Title			
Size A4	Number		Revision
Date:	10.30.2026	Sheet of	
File:	C:_Proj\..\FoxSky.Janus.SchDoc	Drawn By:

Title		
Size A4	Number	Revision
Date: 10.30.2026		Sheet of
File: C:_Proj\..\POWER_CELL_PROTECTION_AND_CHARGING.SchDoc		Drawn By:

Title		
Size: A4	Number	Revision
Date: 10.30.2026		Sheet of
File: C:_Proj\..\POWER_SUPPLY.SchDoc		Drawn By:

Title		
Size: A4	Number	Revision
Date: 10.30.2026		Sheet of
File: C:_Proj\..\MOTOR_DRIVER.SchDoc		Drawn By:

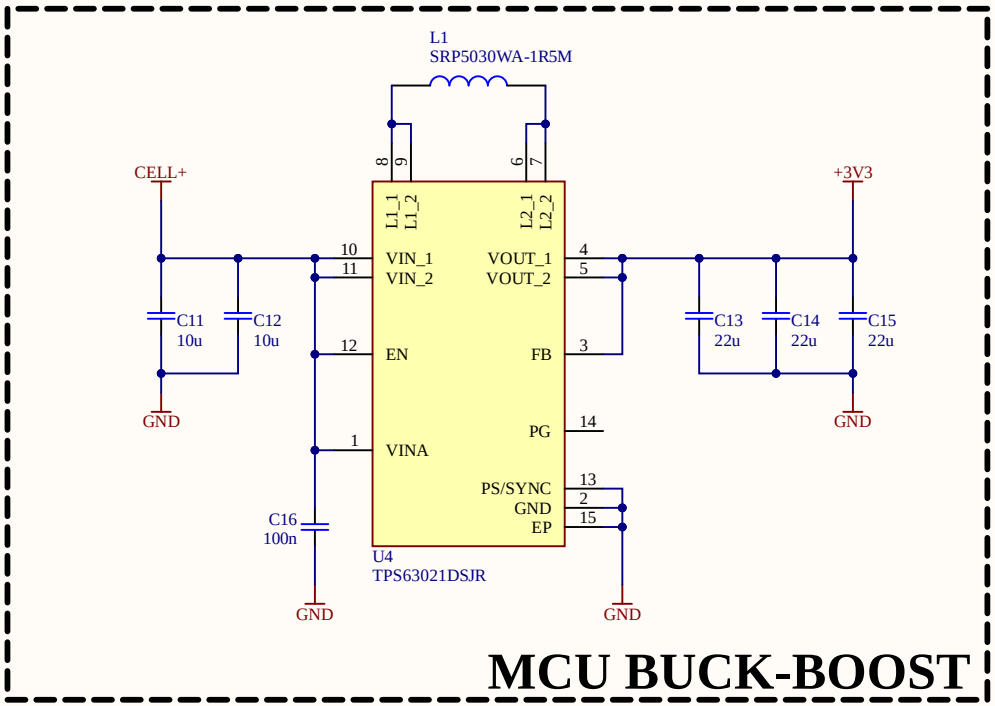
place charging indicating diodes and maybe termistor (103AT) to TS, for now only 10k will replace it

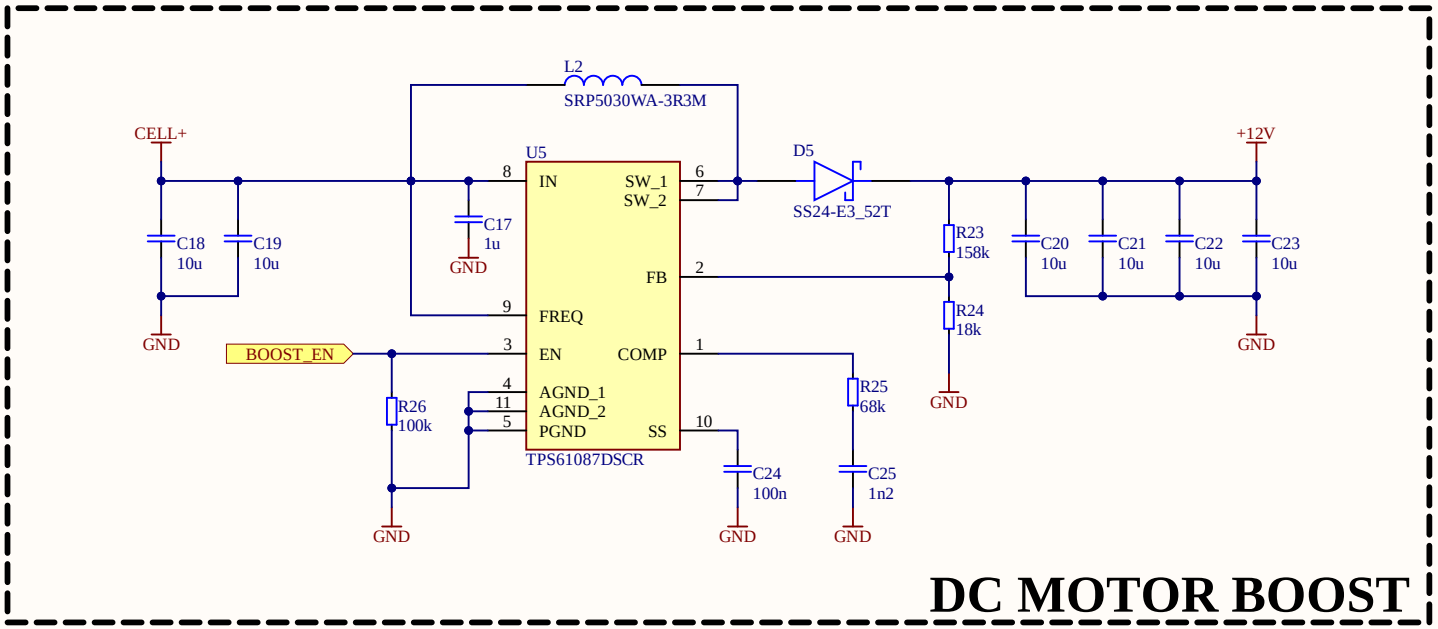
sa we tend to use electromagnetic clutch we need potentially use another 12V boost if the current supply isnt enough

DC MOTOR DRIVER

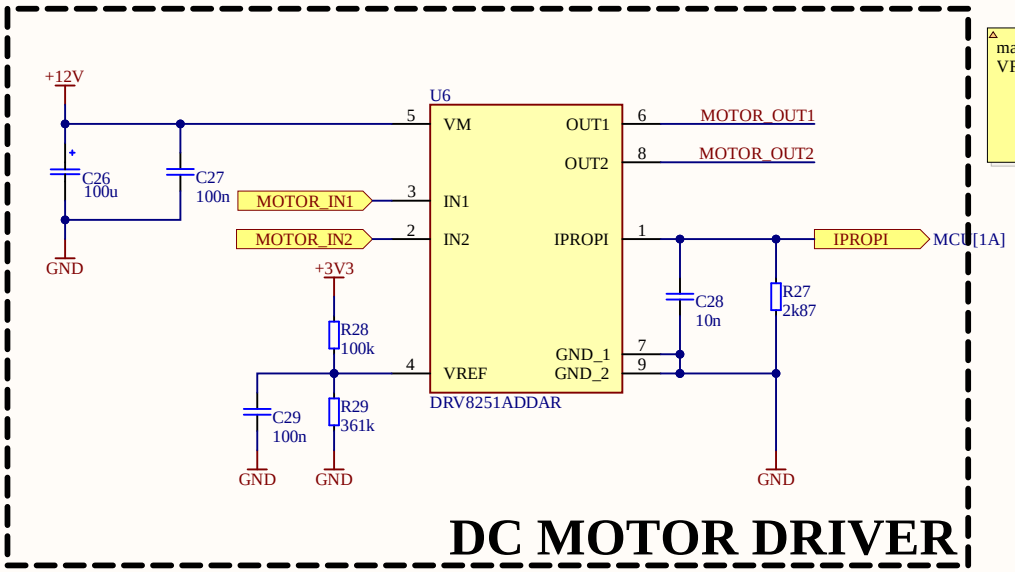
maybe use BOOST_EN to power the VREF divider

MOTOR LINES PROTECTION

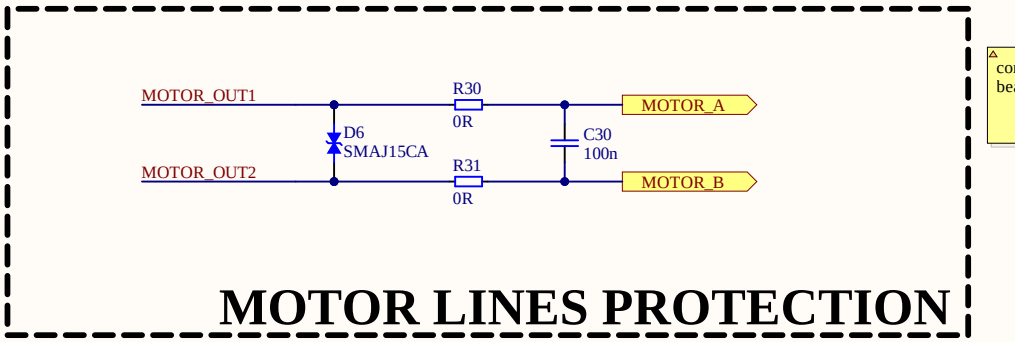
consider building pi filter by placing ferrite beads instead of 0R
